**COUNTY OF SAN MATEO**  
**PLANNING AND BUILDING**

**SUBJECT: Coastside Design Review Continuation**  
208 Magellan Avenue, Miramar  
APN 048-031-200; County File No. PLN 2018-00490

NEW MITHAL RESIDENCE  
MAGELLAN AVENUE  
HALF MOON BAY, CA

**BUILDING SECTIONS**  
**AND FLOOR AREA CALCS**

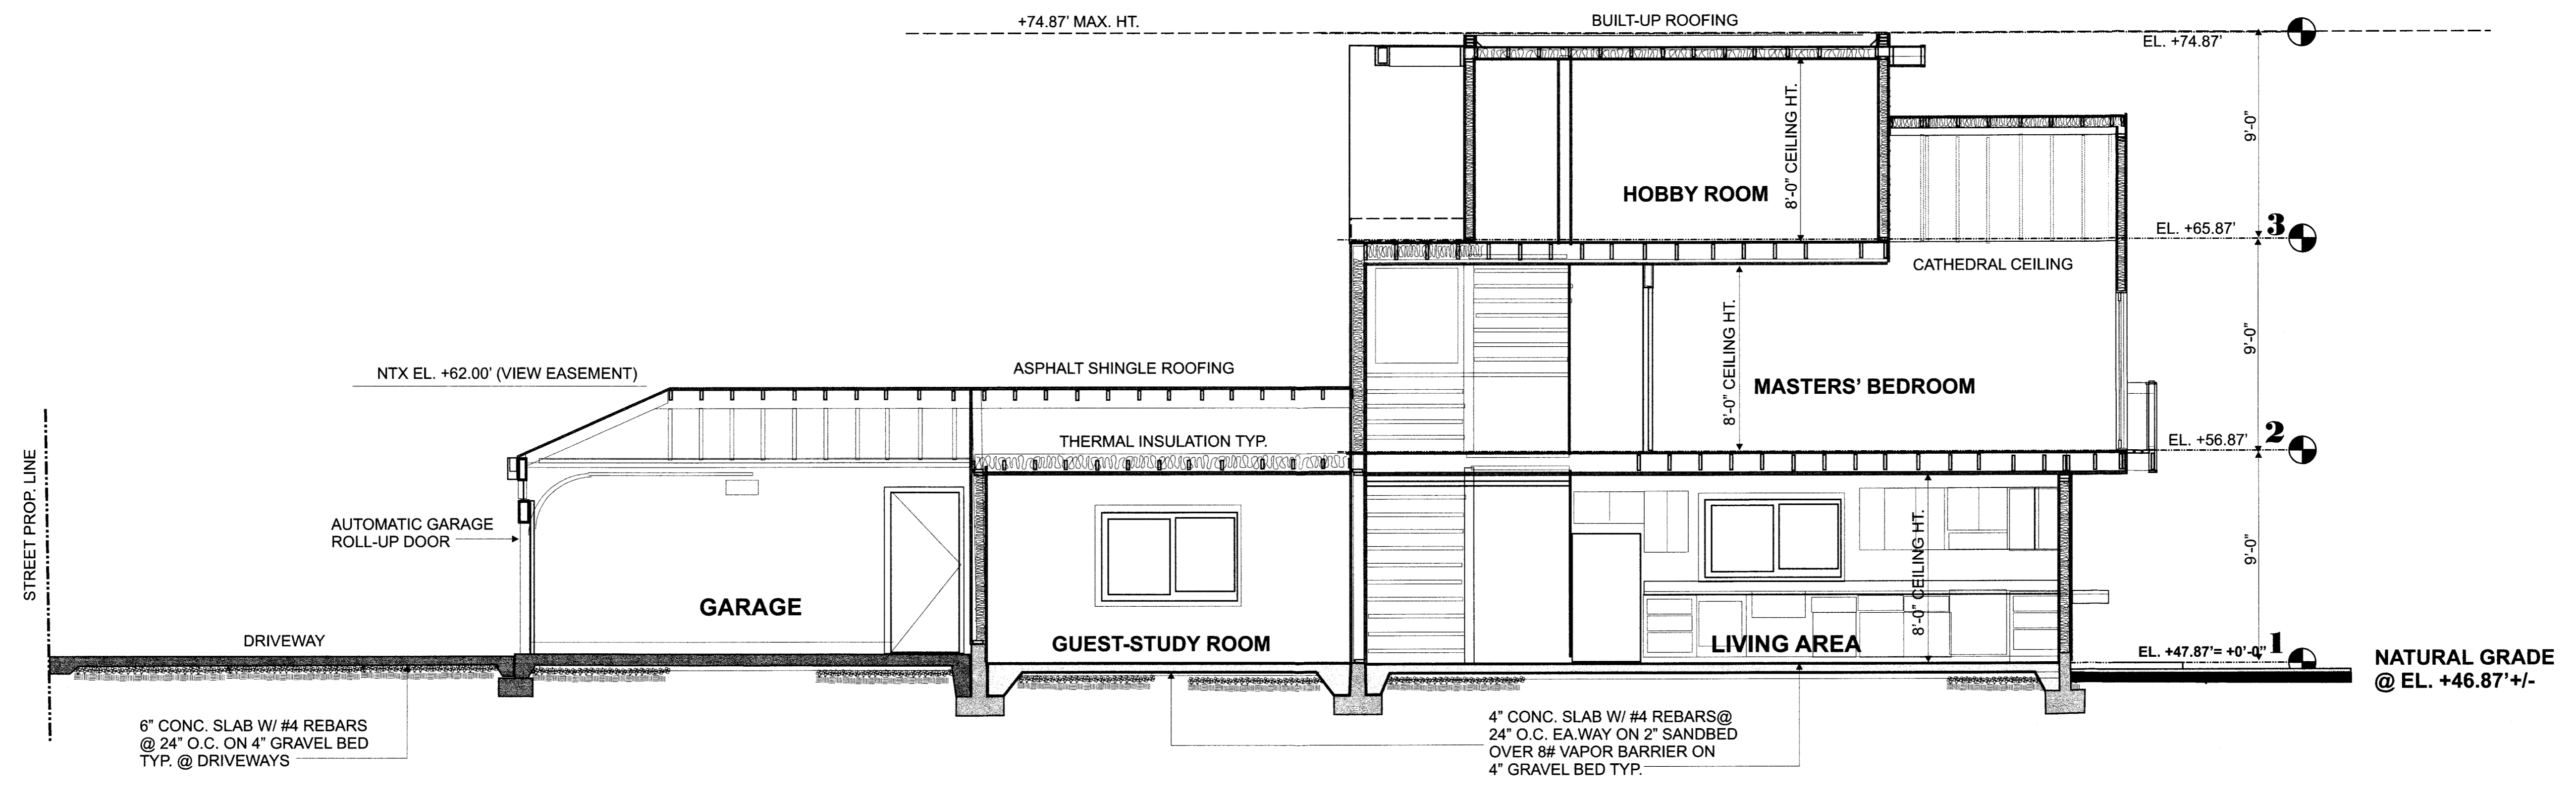
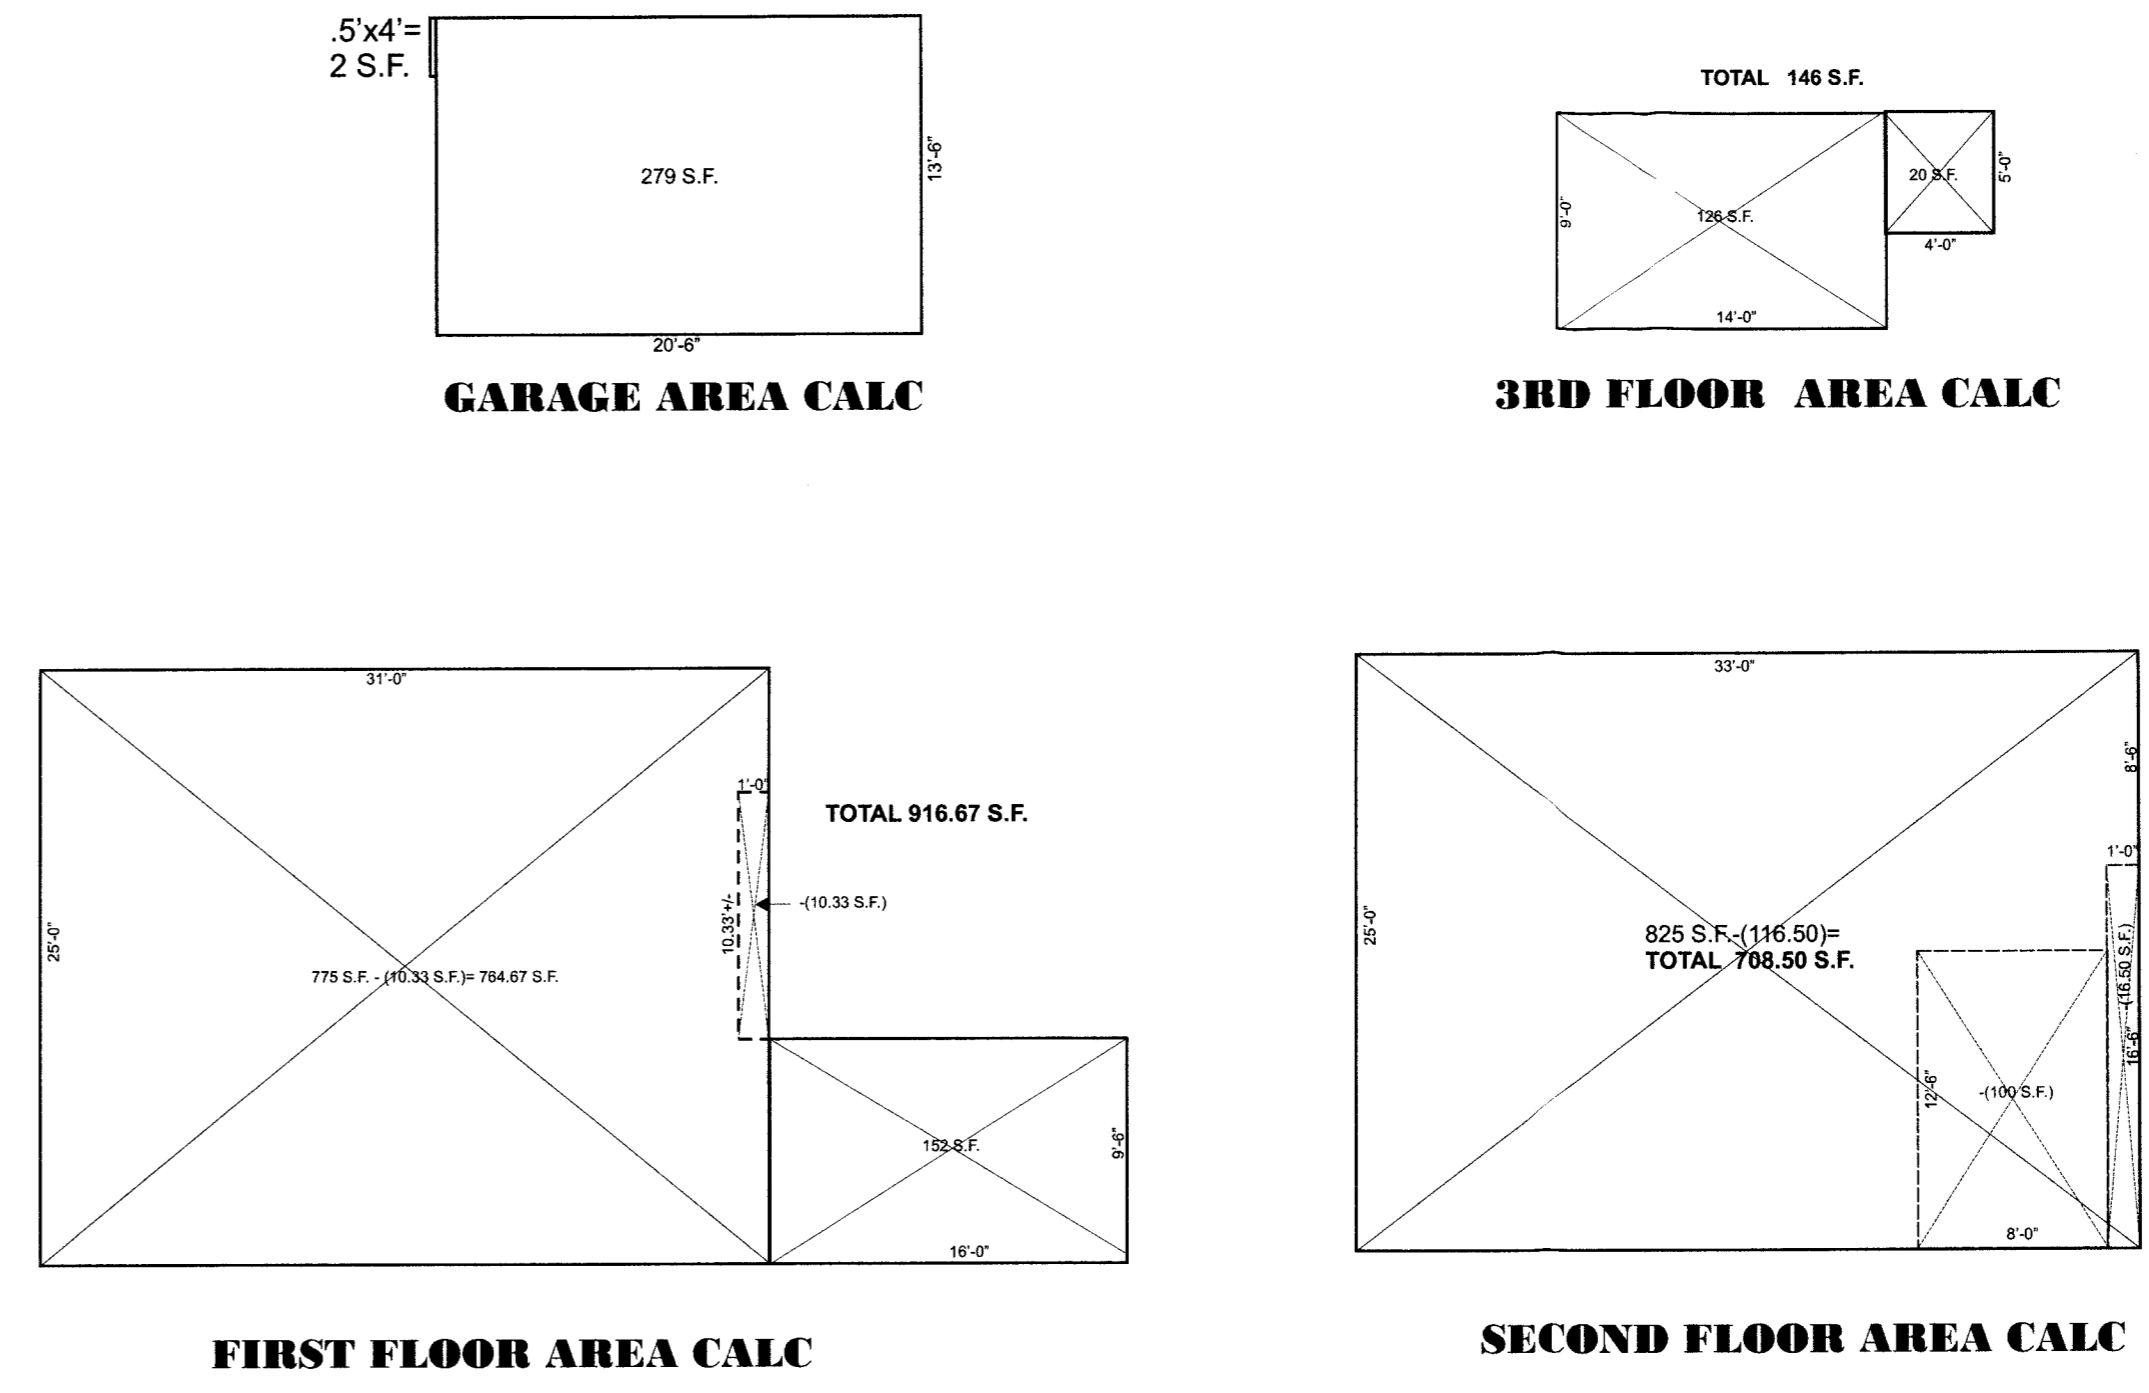
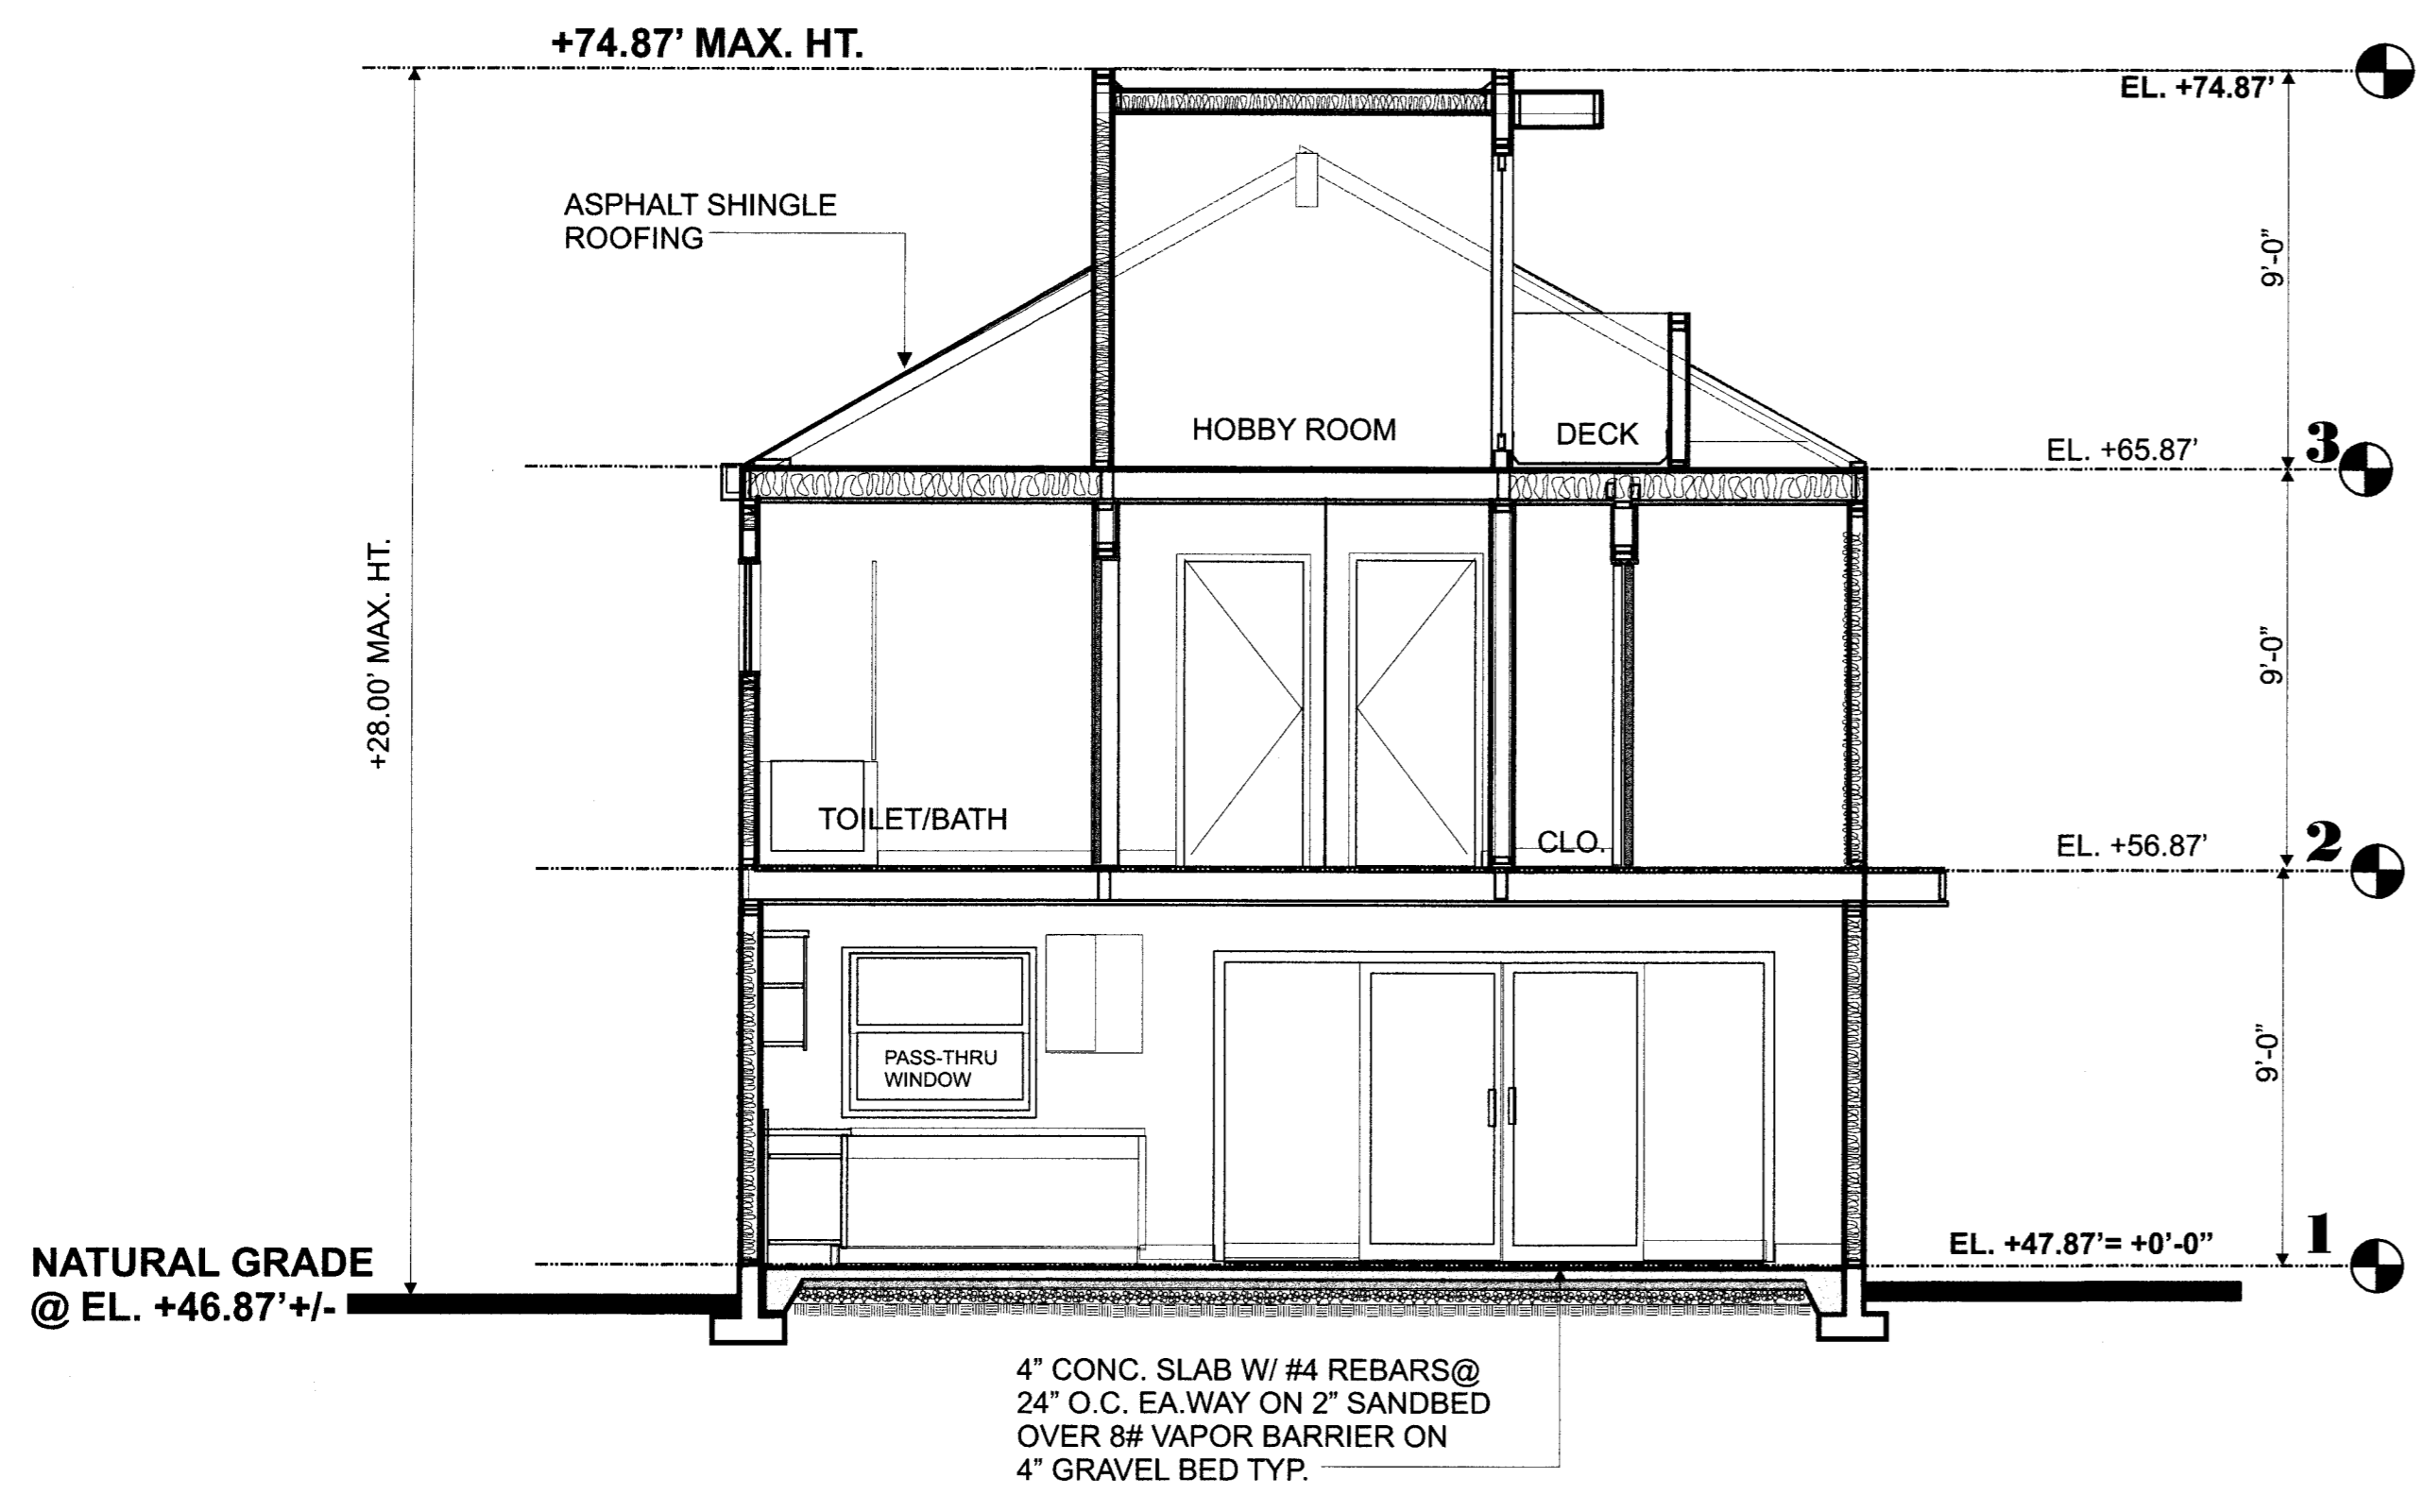
9. Provide dimensional area block diagram with accurate Floor Area Ratio calculations per Zoning Regulations.
10. Remove stairs from garage side door landing.
